ENVIRONMENTAL REVIEW TEAM REPORT ON MEADOWBROOK SUBDIVISION SALEM, CONNECTICUT MAY, 1977

Project CPA-CT-01-00-1045

EASTERN CONNECTICUT RESOURCE CONSERVATION AND DEVELOPMENT PROJECT Environmental Review Team
139 Boswell Avenue
Norwich, Connecticut 06360

SOIL MAP

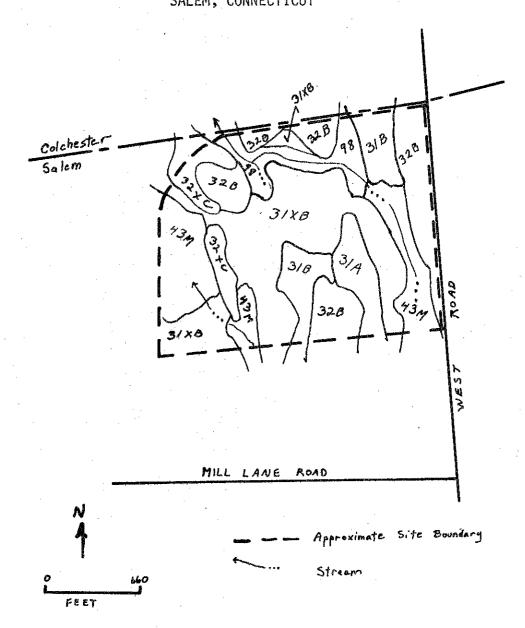
A detailed soil map of the site is provided here. The soil boundary lines should not be taken as absolute boundaries but rather as guidelines to the distribution of soil types on the property. In general, this detailed soil map provides Town officials and the developer with significant information concerning the potential opportunities as well as the limitations for development of the proposed Meadowbrook Subdivision. The percolation and deep hole tests provide information on the actual lot by lot conditions which will contribute to the ultimate decision-making regarding the approval or disapproval of individual lots. Such on-site tests performed in the spring (or wettest time of the year) are most valuable as they will usually indicate the worst conditions around which to plan land use.

In general, the greatest limiting factor to the proposed subdivision appears to be the high water table which can be considered seasonal in some of the moderately well drained Woodbridge soils, (31A, 31B, 31XB) and fairly year-round in the poorly drained Ridgebury soils (43M and 98, which are also inland wetland soils regulated under Public Act 155). Approximately 75% of the total site acreage is composed of soils exhibiting some high groundwater condition. This is considered to a severe limitation to the operation of a subsurface sewage disposal system.

Regarding the inland wetland soils on-site, 43M is a Ridgebury/Whitman/
Leicester complex meaning that the soils occur in an intricate and complex pattern
and separation of each of the three individual soils is not practical on the scale
surveyed. In general, 43M is an extremely stony unit made up of poorly and very
poorly drained soils. These soils are characterized by a relatively thin, darkcolored surface horizon over a gray mottled subsurface horizon. They occupy lowlying to gently sloping areas exhibiting an extremely stony or completely stonecovered surface. As these soils have developed in very firm glacial till, a hardpan at about two feet in depth is not uncommon. The groundwater table is on or
near the surface from late fall through early spring, but may drop below six feet
in late summer and fall. Poorly drained Ridgebury soil 98 has a hardpan at about
two feet in depth. Like the 43M, the subsurface horizon is mottled, and the 98

Regarding the other soils on-site exhibiting a seasonal high water table, the Woodbridge soil units (31A, 31B, and 31XB) are moderately well drained soils with a slowly to very slowly permeable hardpan at about two feet in depth. The lower subsoil is mottled, indicating a waterlogged condition from late fall until early spring and after heavy rains in the summer. As these soils are only moderately permeable above the hardpan, water will move laterally down-slope over the pan in wet seasons. This can be a serious limiting factor in the operation of a subsurface sewage disposal system. Surface stoniness varies from essentially stone-free on areas where stones have been removed to extremely stony.
